Arizona Public Service Company (APS) is authorized to operate the facility at reactor core power levels not in excess of 3990 megawatts thermal (100% power) in accordance with the conditions specified herein.

PALO VERDE UNITS 1 AND 3  
PALO VERDE UNIT 2

AMENDMENT NO. ~~117~~, 119  
AMENDMENT NO. ~~119~~ 149

Figure 3.4.1-1, (Page 2 of 2)  
Reactor Coolant Cold Leg Temperature vs. Core Power Level

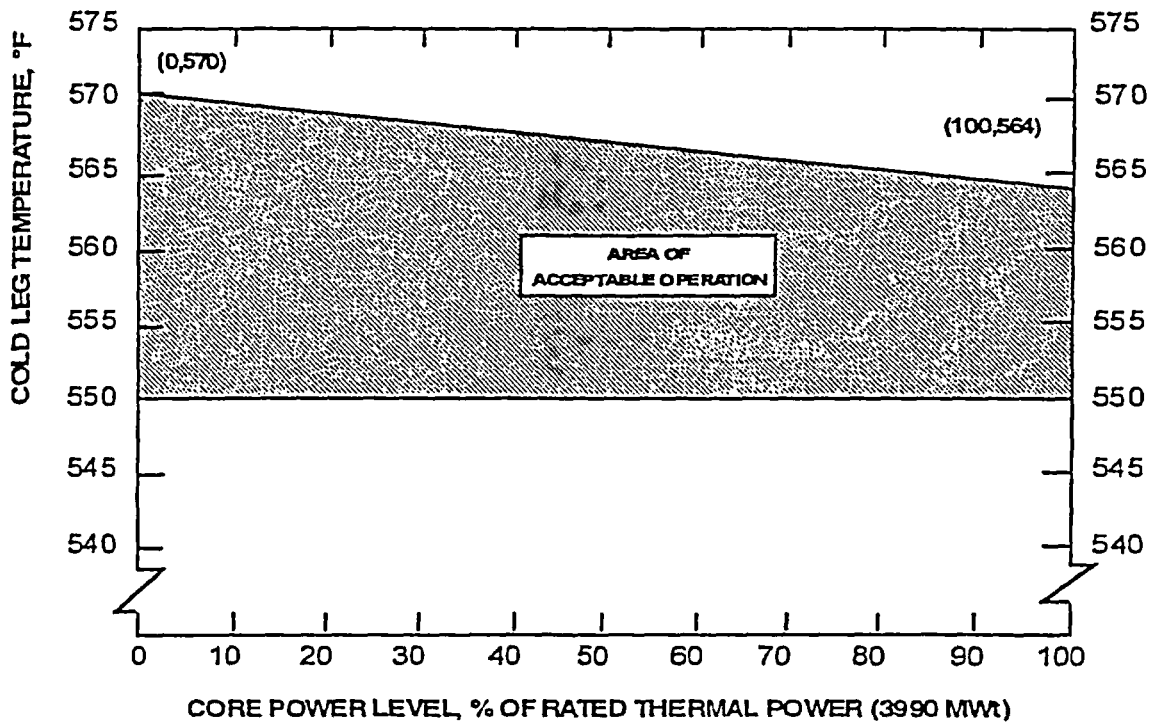
Unit 2
